Green Building/Energy Review Responses

Montgomery County
Department Of Permitting Services

Review Comments For:
Carpenter Shop Servant Quarters
2715 Cassidy Street
Silver Spring, MD 20910

A/P#: 725266+269 thru 272+274

A14

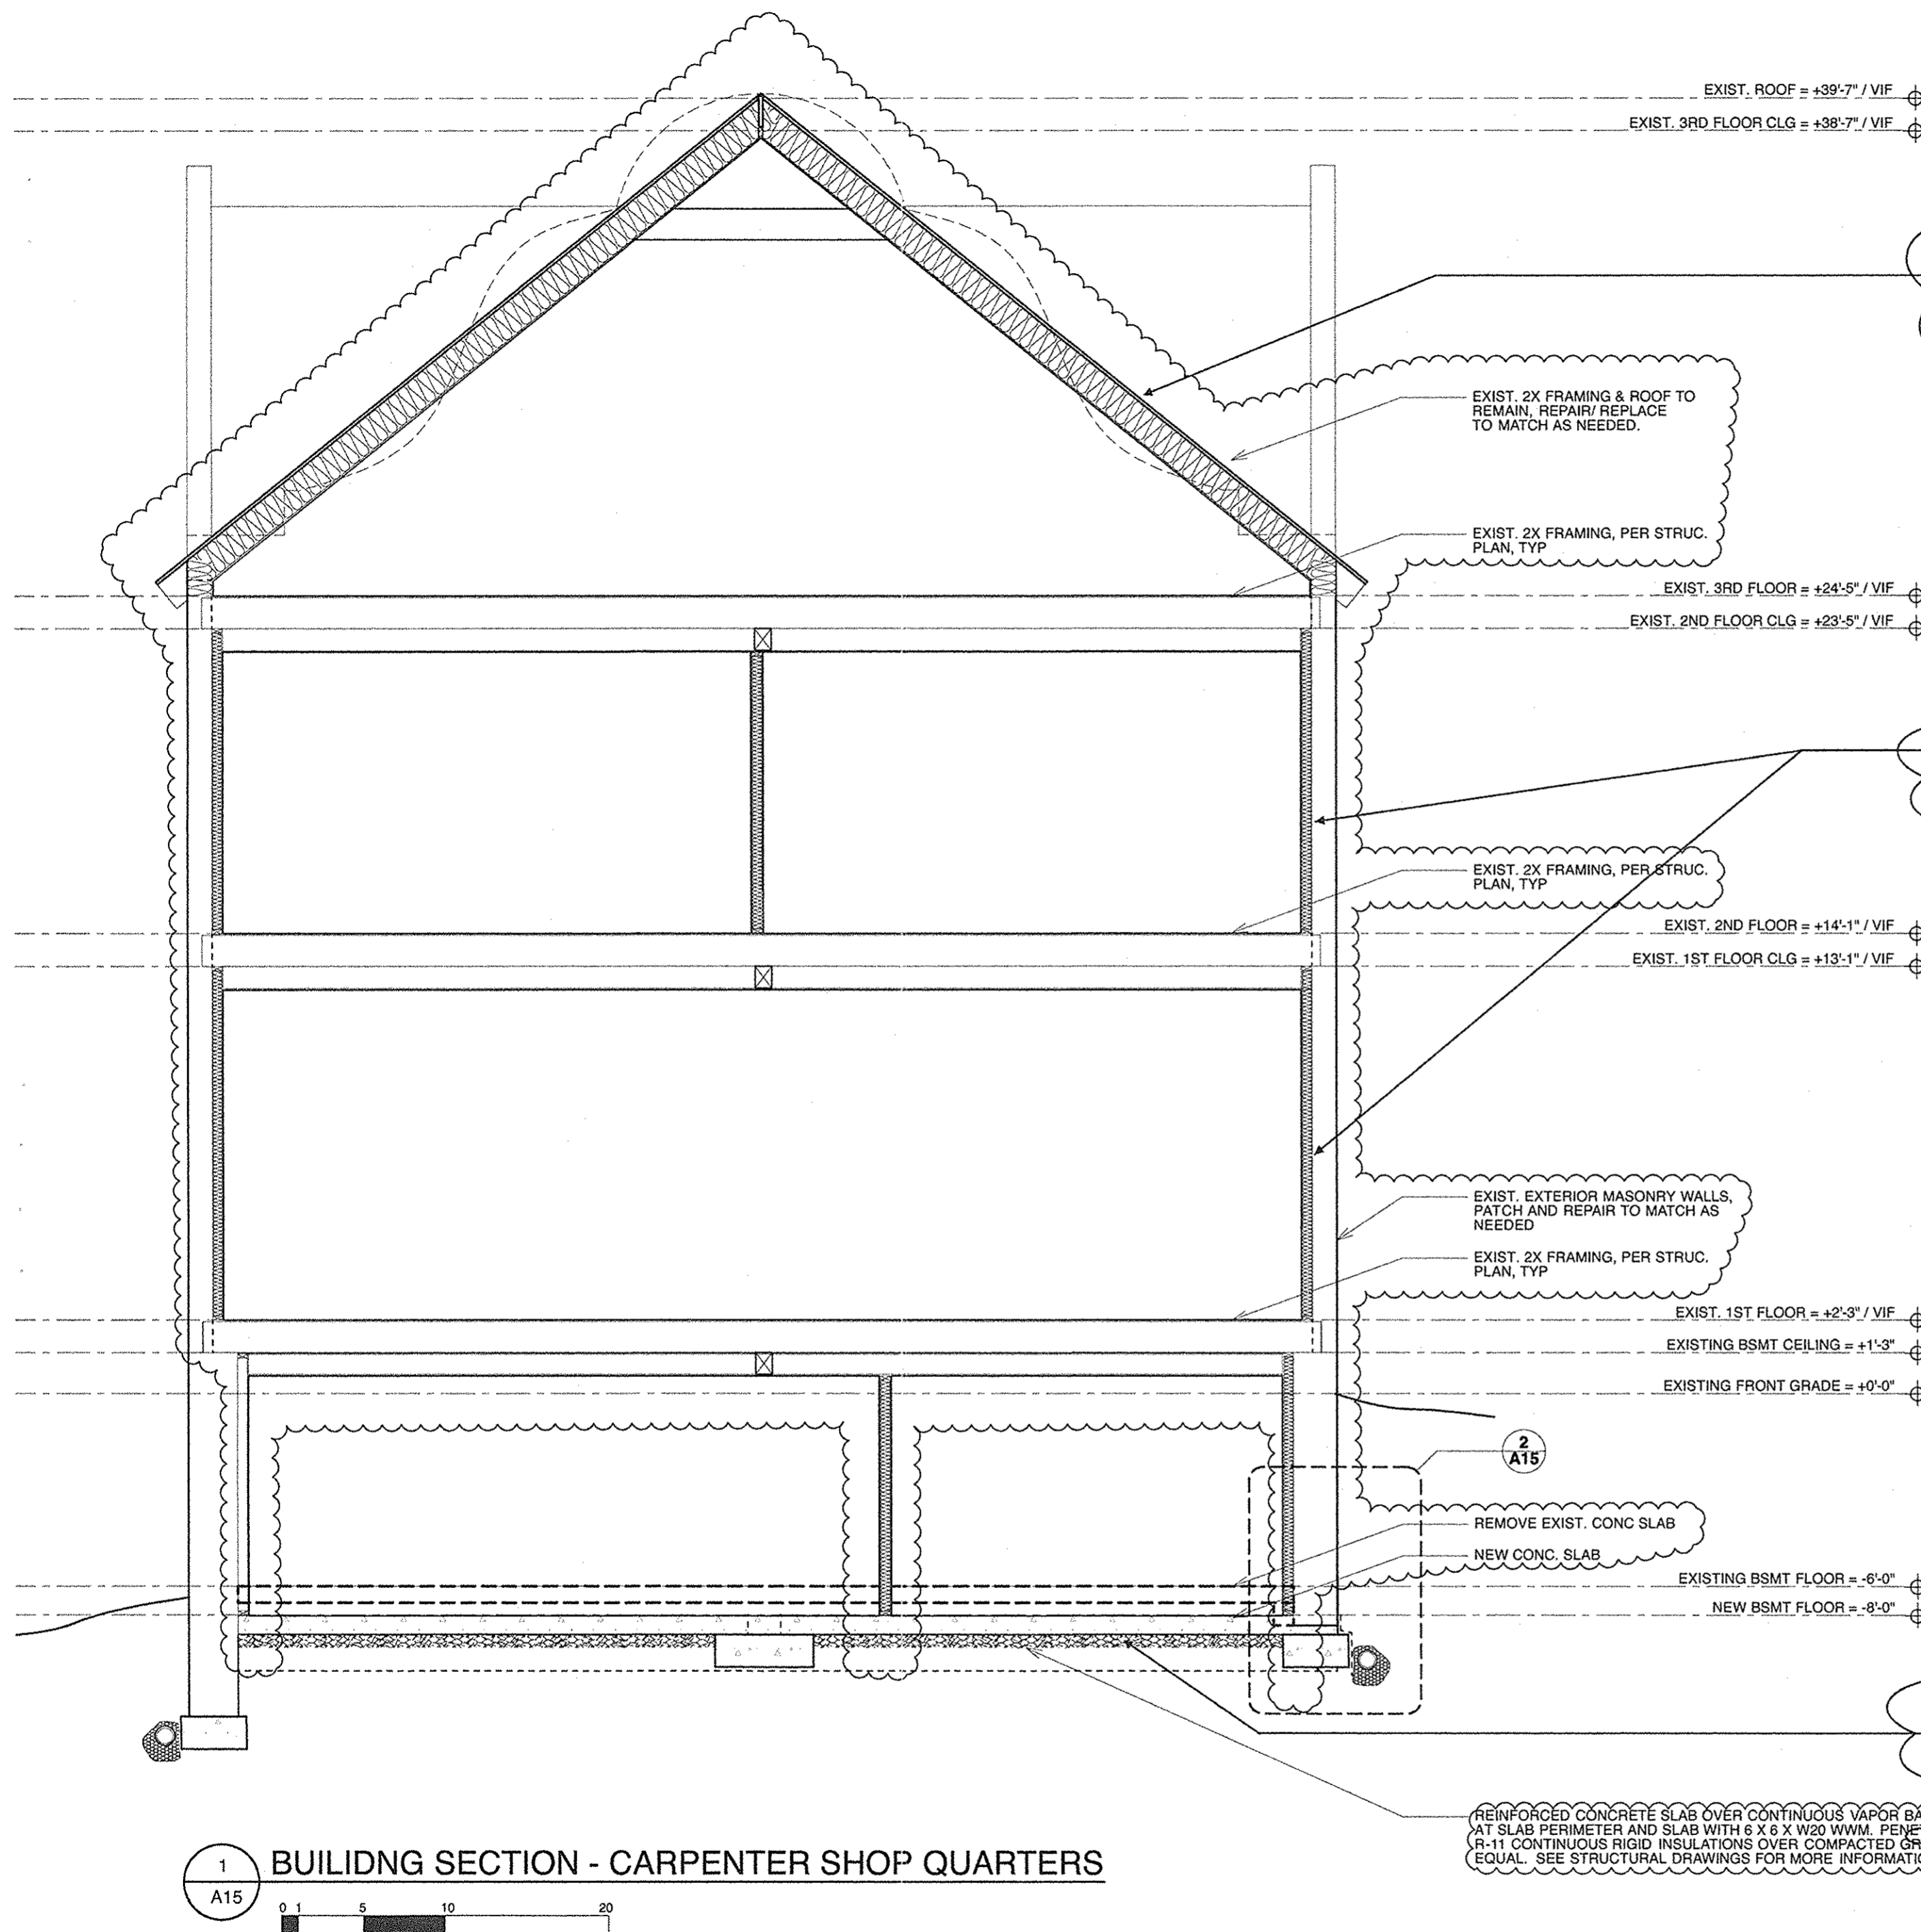
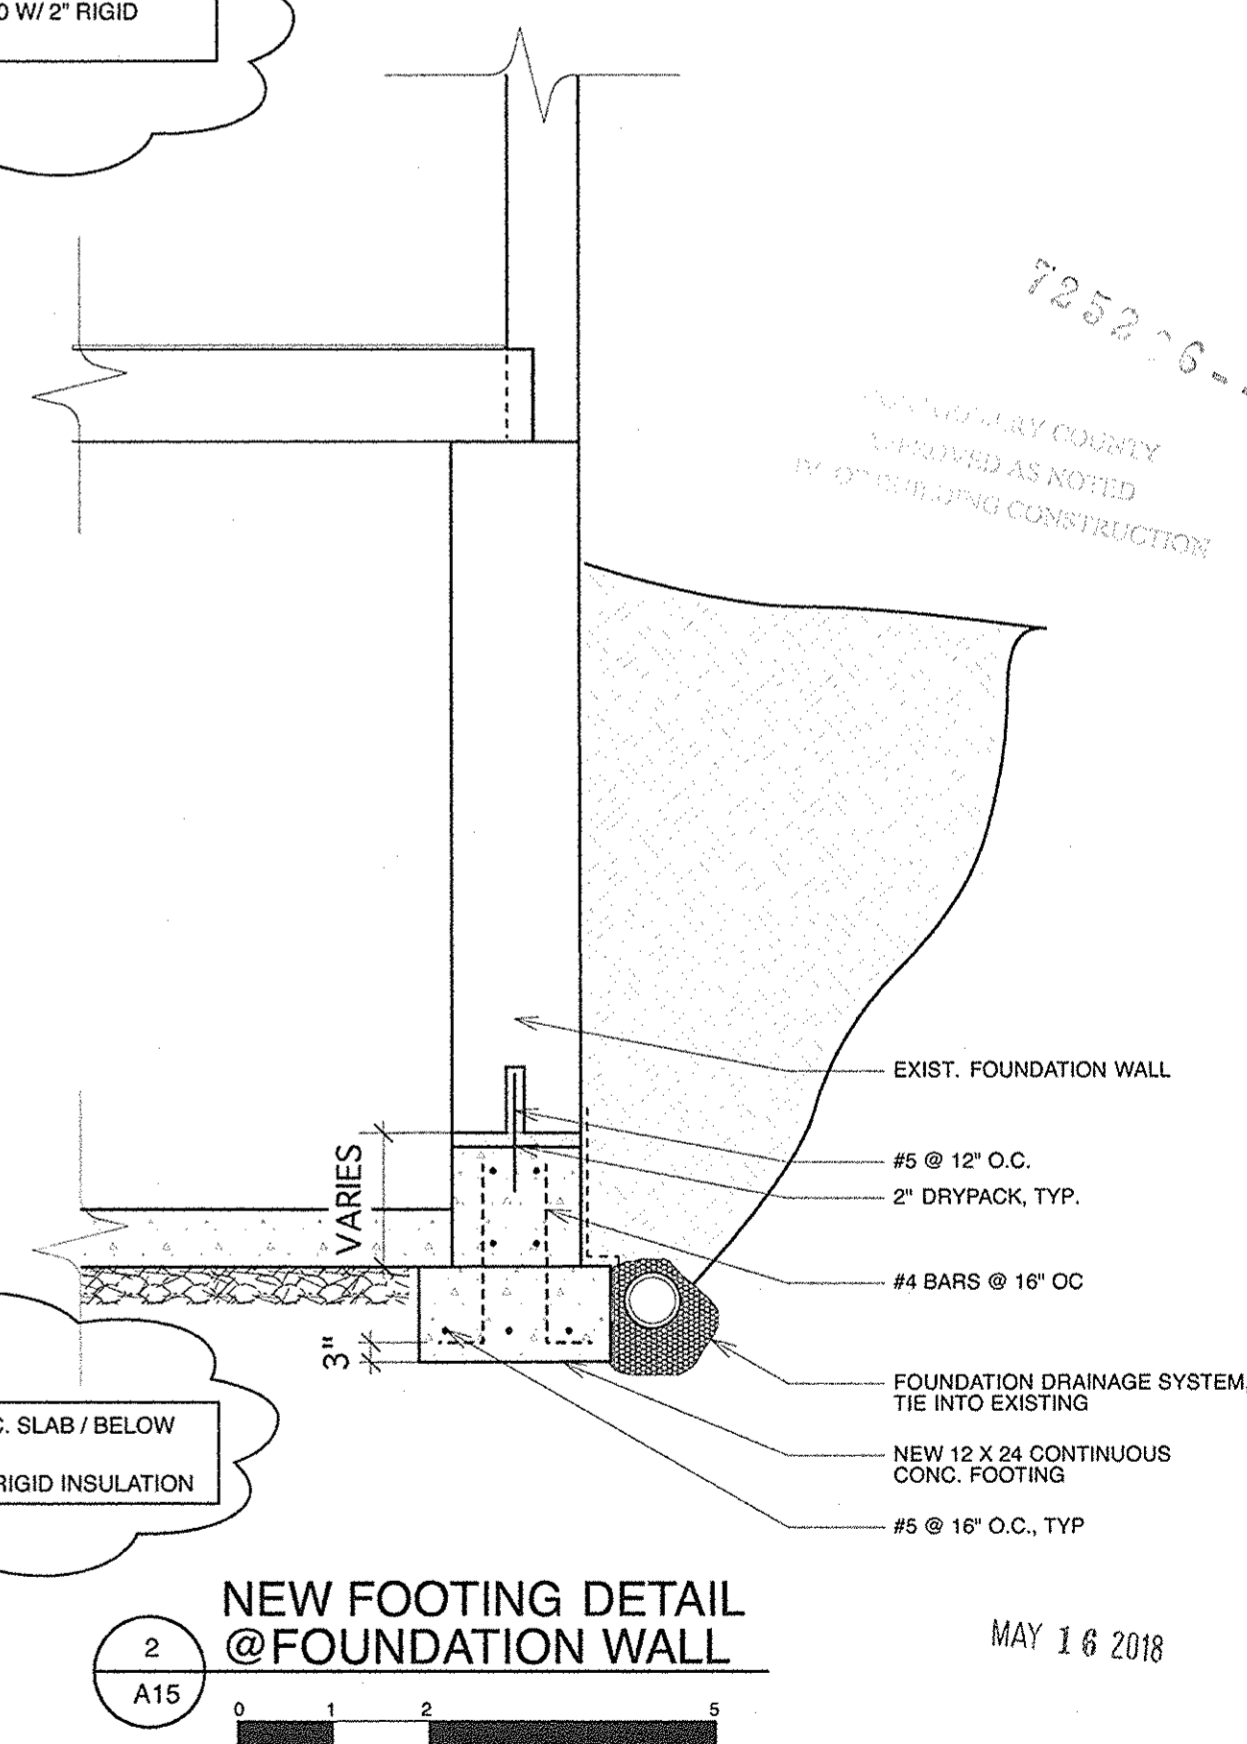
1. ***Provide code compliance information of building envelope for all the proposed alterations to the existing roof ceiling and exterior walls per C402.***

We have added, to sheets A15, A16, and A17, the insulation information related to the existing structure that can be accomplished that would otherwise not “threaten, degrade or destroy the historic form, fabric or function of the building”. Note that no alternations to the existing structure is occurring other than replacement of windows and repairing exterior roofing and brick masonry walls.
2. ***All exit doors and glazing walls / windows in the exterior walls must meet minimum requirements of R-values, fenestration, maximum U-factor and SHGC per C402.***
 - a. See revised sheets A8.10 and A12, A13, A13a and A14 with those additional noted requirements. Although the primary building structure, as noted above, is a registered historic structure, new windows and doors will be in compliance with this section.

EXISTING ROOF FRAMING TO REMAIN.
 TYPICAL ROOF ASSEMBLY:
 • MIN. INSTALL AIR-IMPERMEABLE INSULATION AT UNDERSIDE OF ROOF DECKING, TO R-49 DEPTH.
 05/07/2018

EXISTING MASONRY WALL TO REMAIN: MIN. R-10 W/ 2" RIGID INSULATION
 05/07/2018

BASEMENT CONC. SLAB / BELOW GRADE:
 • MIN. R-10 W/ 2" RIGID INSULATION
 05/07/2018

1 BUILDING SECTION - SERVANTS QUARTERS
A17

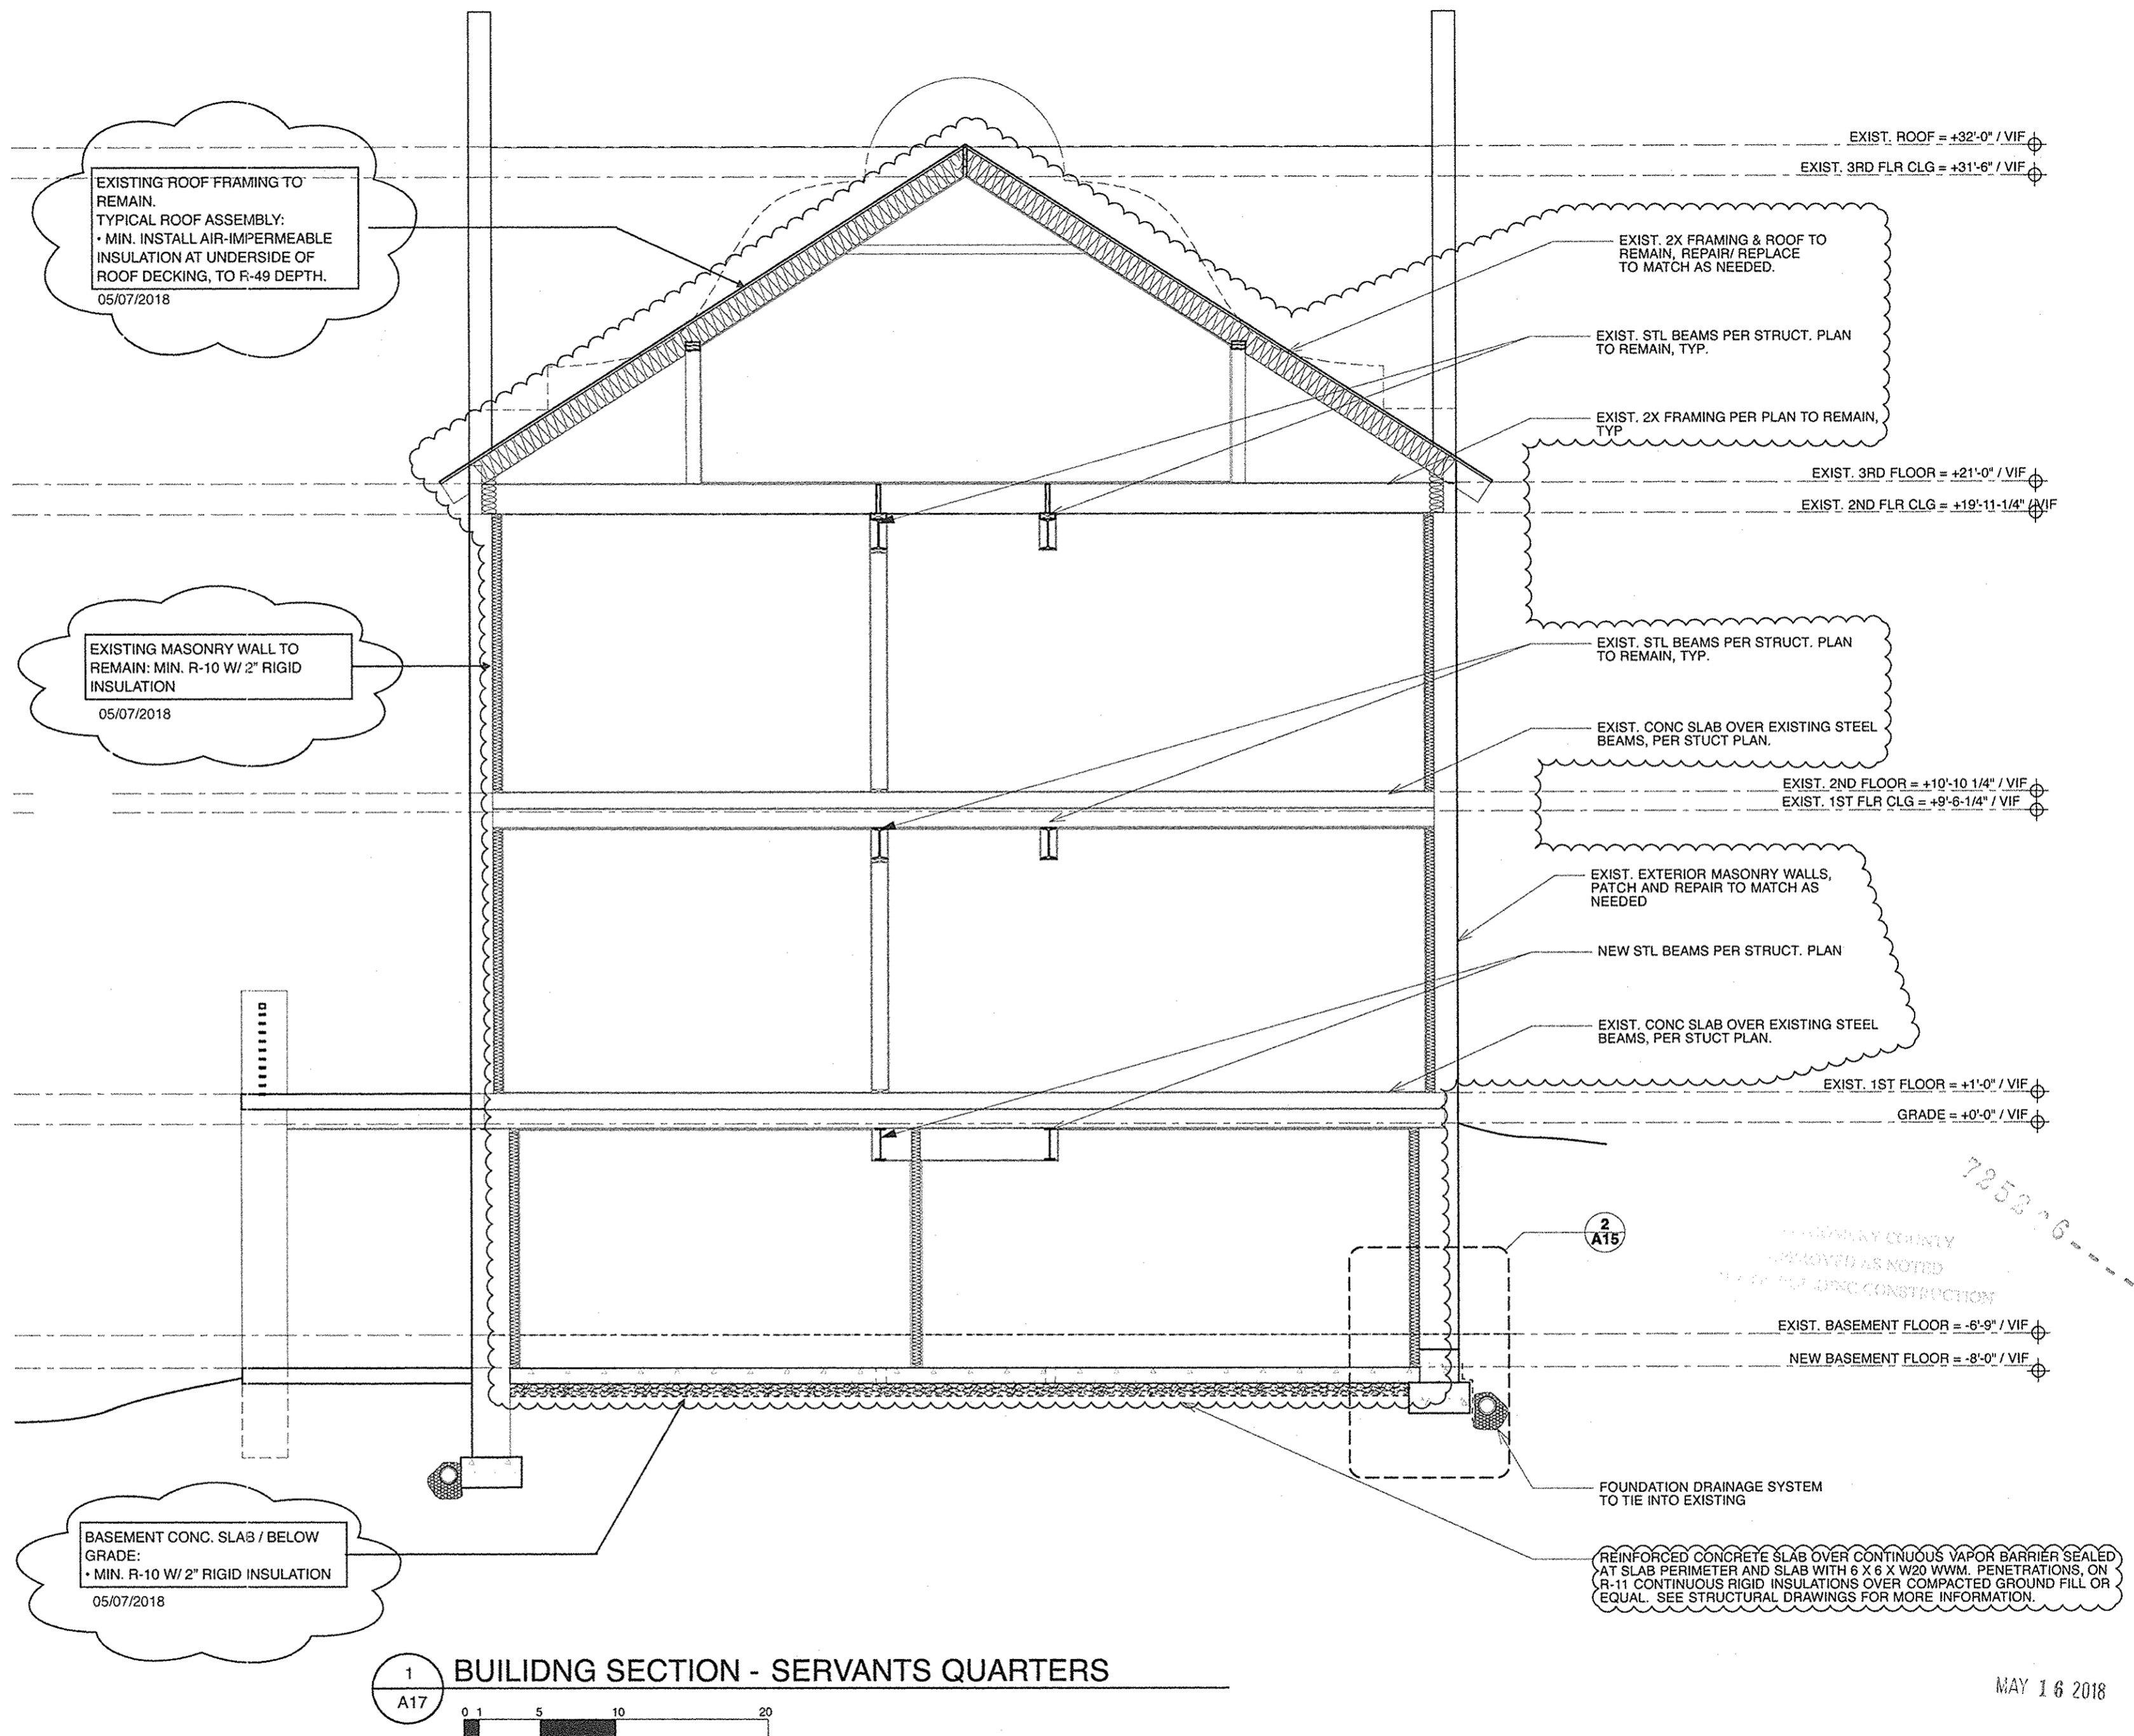
1. Responded
2. See previous comment, Drawing A15, A16 and A17 still shows information not matching with each other. SER shall provide response in writing **detailing how the comment has been addressed.**

Previous comment: Drawing 15, section 1 shows that the existing slab on grade will be lowered 2 ft at carpenter shop but the drawing A16 section 1 shows will be lowered 3", in both cases detail 2/A16 is not applicable top of slab elevation will not be same if the existing slab is lowered. Verify existing and proposed slab on grade elevations. Underpinning locations, sequence of underpinning detail /construction shall be shown on plan. Section 2/A15, shows a new footing below the existing wall, verify how the footing can be installed. Structural engineer of record shall sign and sealed any structural details shown on architectural drawings such as underpinning detail, 1/A15, 3/A16 etc. Responses to structural comments shall be provided by structural engineer of record with a letter head. Drawing S6 underpinning note shall provide maximum sequence width length at a time, also where the soil bearing capacity of 4000 psf is obtained. Building footings were designed for 1500 psf and SER recommends 4000 psf for underpinning design. SER to provide all responses.

- A) Please see sheet S1, the three existing buildings are separate and there is no direct path of travel between the building A, B or C. One must exit one building to enter another. The existing slab elevations are noted on sheet S1 and the new elevations noted on sheet S7.
- B) The underpinning sheet , S6 has been updated to show the underpinning of the walls and columns.
